CITY OF PORTLAND, MAINE
DEVELOPMENT REVIEW APPLICATION
PLANNING DEPARTMENT PROCESSING FORM
DRC Copy

single family dwelling
Project Name/Description

225 - 225 Brackett Ave, Portland, Maine

RE: 219 Brackett Avenue, Peaks Island
(ID # 2004-0080, CBL #088M006)

SUBSURFACE WASTEWATER DISPOSAL PLAN Scale: 1" = 20' ft

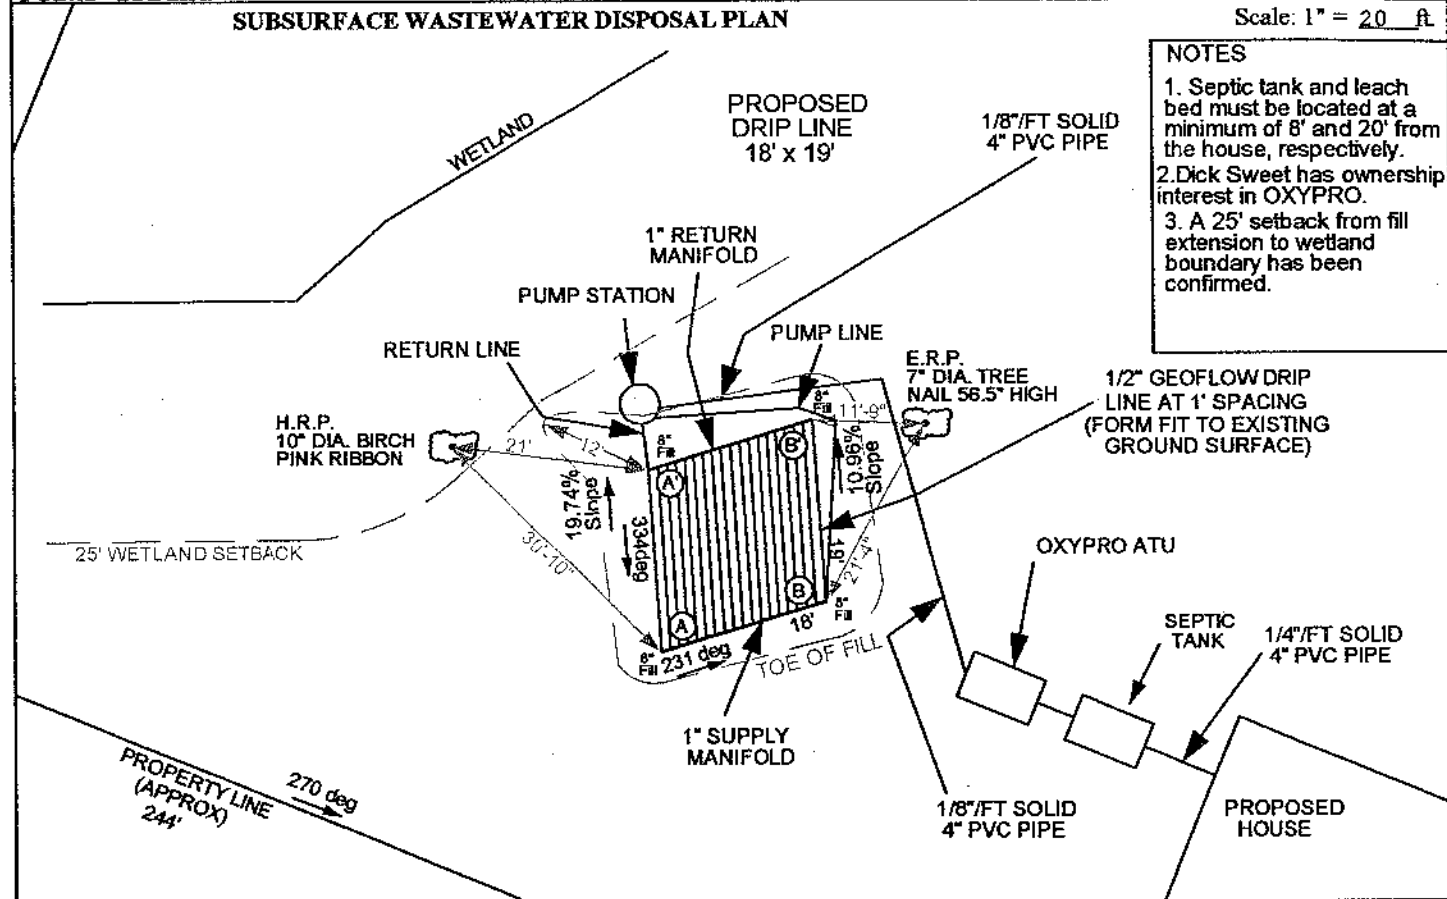
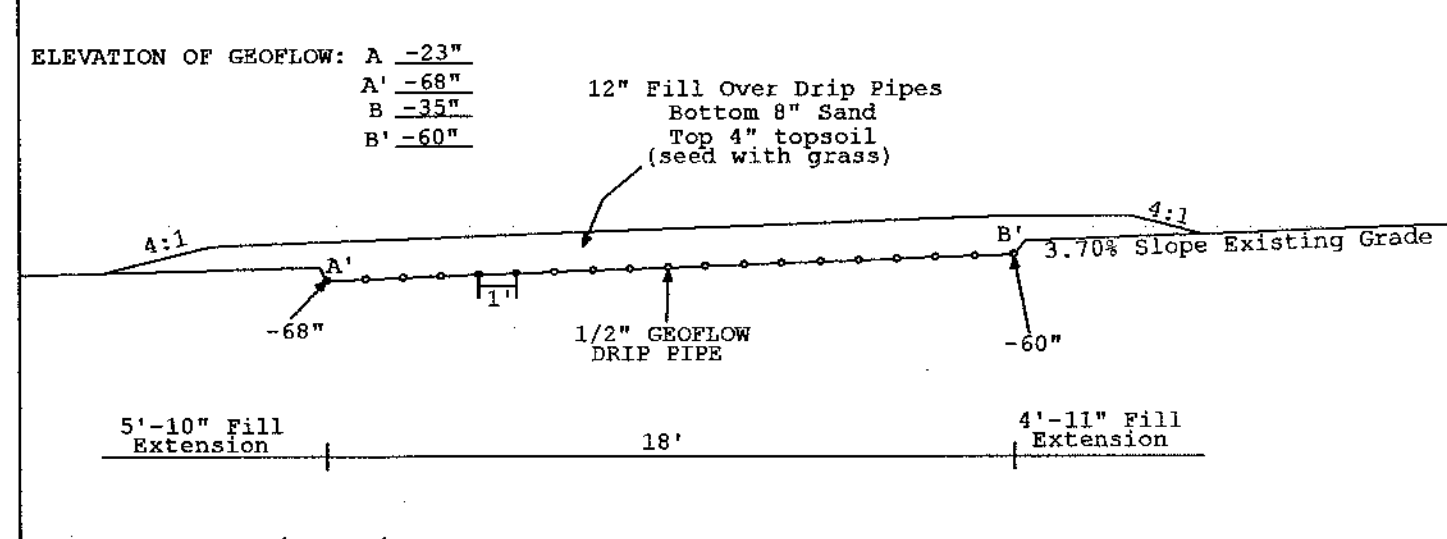
3. In SECTION 14-449 LAND USE STANDARDS, I found the requirement for a 75' setback from the up-land edge of a wetland. The proposed structure in the plot plan meets this requirement. However, the septic proposal does not. I have a couple of questions regarding this.

1. Wetlands have been flagged by Sweets Associates, who are Maine State certified geologists. These flags were then located on the survey prepared by SGC Engineering, LLC.
2. As a result of finding wetlands on the property, I am also submitting a redesign to the septic system, prepared by Sweets Associates. This proposal follows regulations set forth by the Maine Subsurface Waste Water Disposal Rules, 144A CMR 241.

- NOTES**
1. Septic tank and leach bed must be located at a minimum of 8' and 20' from the house, respectively.
 2. Dick Sweet has ownership interest in OXYPRO.
 3. A 25' setback from fill extension to wetland boundary has been confirmed.

PLOT PLAN
(revised)

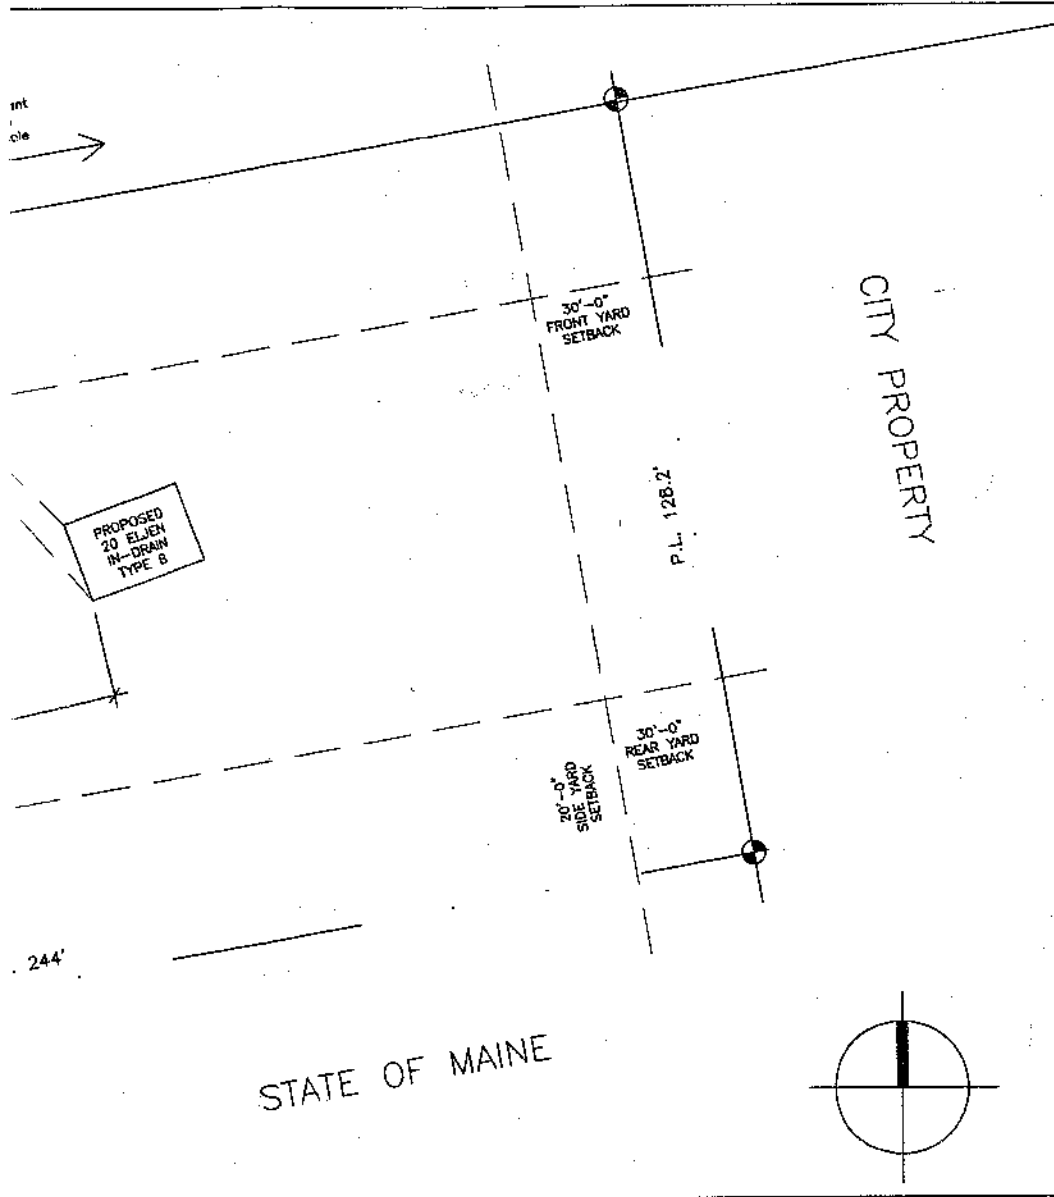
1. Please add any/all proposed changes in grading. Also, add the sill or finish floor elevation.
2. Please add 2 proposed street trees along the ^{*Brackett*} Island Avenue frontage of the lot, as required by ordinance for single-family development. Saving existing healthy trees (as substitutes) is allowed by adding a tree preservation note to the plan.
3. Please show proposed utilities such as water, sewer and storm drain.
4. Please note the distance of the nearest fire hydrant on the site plan.
5. Please indicate any drainage courses, streams, and wetlands. Also, the City's zoning map indicates that there may be a resource protection zone in the vicinity of your lot. Please show this on your site plan.

- ✓ 1. I have added a note which states "existing grade to remain, no proposed changes". As well, I have included copies of the south, west, north and east elevations which show the finish floor elevation.

- ✓ 2. I have added trees and a note which states "all existing healthy trees, a minimum of 6' from the perimeter of the proposed structure, to be preserved on site".

- ✓ 3. I have added a dashed line which shows the path of the proposed water main, as well, I have drawn the proposed septic tank and 20 Eljen In-Drain Type B.

- ✓ 4. I have added the distance and direction of the nearest fire hydrant.
- ✓ 5. I have reviewed the City of Portland Resource Protection and Shoreland Overlay Zones and Floodplains Map. The only Resource Protection Zone I find on Peak's Island is in the location of the "ball field" which is approximately ½ mile away from the proposed site. Therefore, I did not note it on the plot plan. As well, there are no drainage courses, streams or wetlands on the property.
